Response to Submissions

UNSW D14 Academic Building Planning Application SSD 9606

Prepared for
Lendlease on behalf of UNSW
12 April 2019

Figure 12 - Public Space Plan

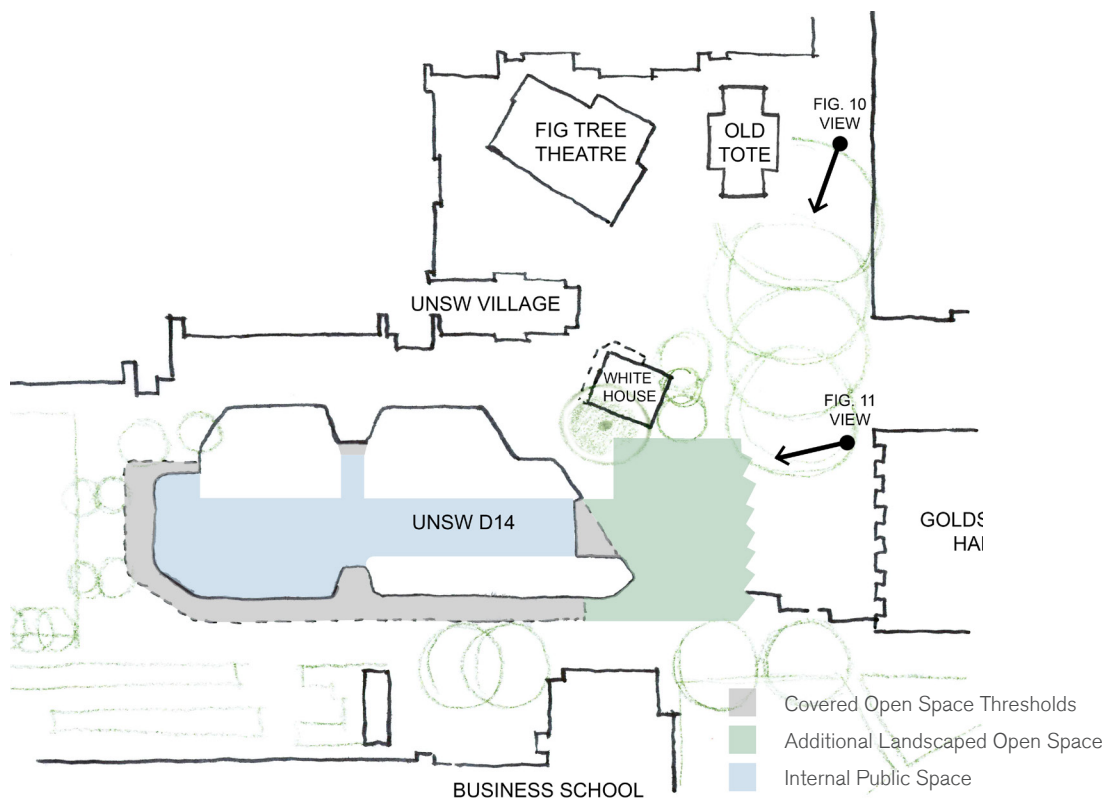
In response to the submissions, the existing tree behind White House is proposed to be retained. This provides an encircling landscaped setting to the heritage item and a threshold between D14, thereby improving the spatial quality of the new public space.

Figure 18 - Aerial Perspective

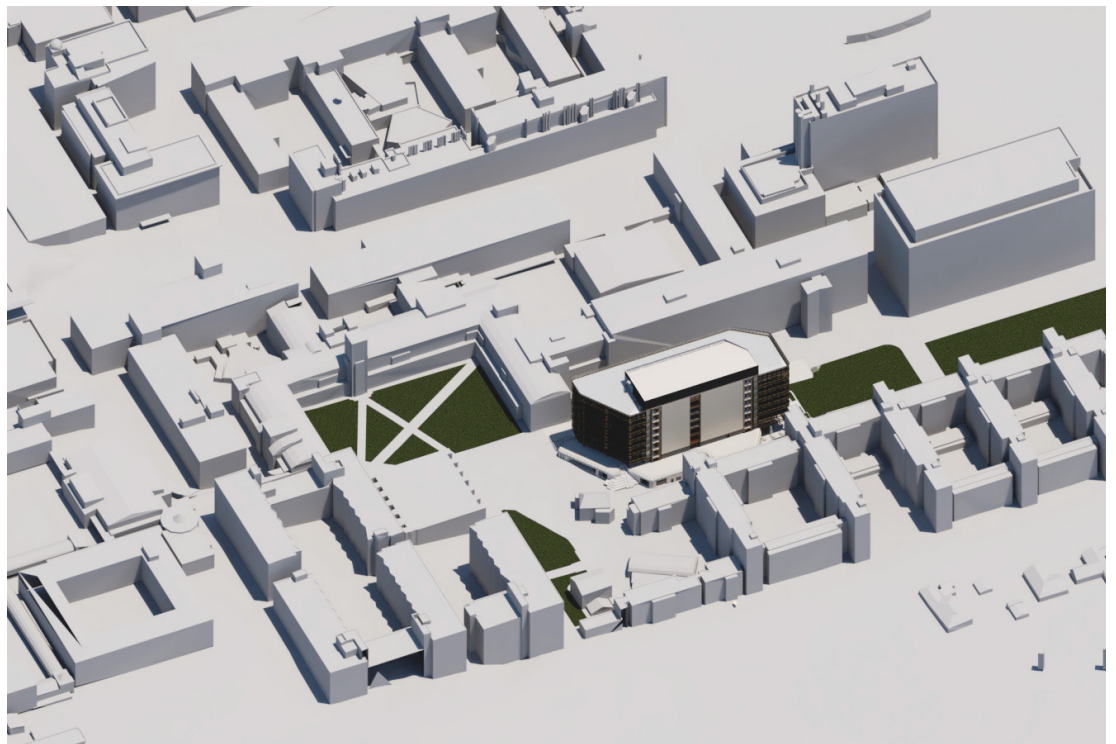
As evidenced by the aerial perspective below, the bulk and scale of the overall development is in keeping with the adjacent UNSW Village, Australian School of Business and recently completed Hillmer Building. The response to submissions also identifies concerns about the bulk and scale of the masonry ground plane element and its interface with the White House. This single storey element with bleachers and terrace above mitigates the change in scale between the two buildings and provides an intimate frontage to the White House as shown in Figure 3. Bleachers erode the edge of the terrace and provide a seamless transition between D14, the ground plane and White House beyond.
